**HIROSE ELECTRIC CO., LTD.**  
2-6-3 Nakagawa Chuoh, Tsuzuki-ku, Yokohama, JAPAN

### Product Change Notification

## ■Product List PCN2020-24-1\_【Revised&amp;Reissued】EF2-D30, D60 Product specification change

■ Changes PCN2020-24-1\_【Revised&Reissued】EF2-D30, D60 Product specification change

【Current product】	【Replacement product】
Housing

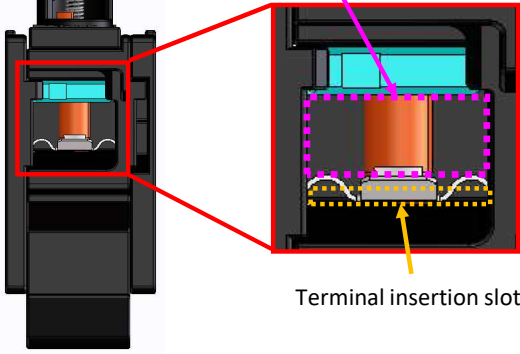
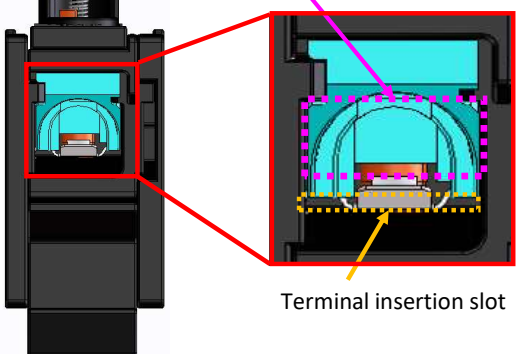
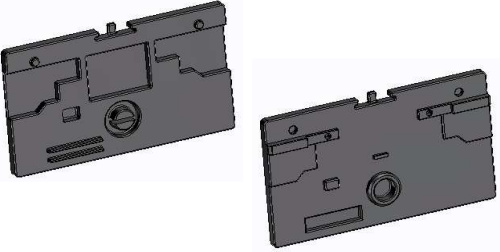
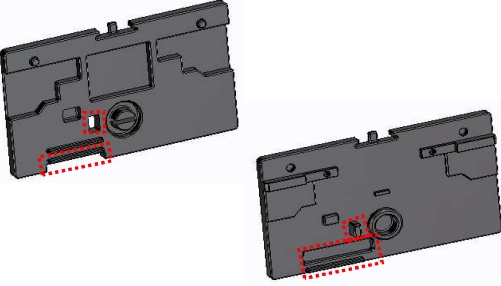
<p data-bbox="363 1088 722 1115">There is space for terminal to enter</p>  <p data-bbox="507 1417 738 1444">Terminal insertion slot</p>	<p data-bbox="906 1088 1297 1115">There is no space for terminal to enter.</p>  <p data-bbox="1090 1417 1321 1444">Terminal insertion slot</p>
End plate * Only for EF2-D30-1, EF2-D60-1

<p data-bbox="196 2011 411 2038">  ...Changes         </p> <p data-bbox="204 2051 858 2078">These changes will not affect the performances of the product.</p>
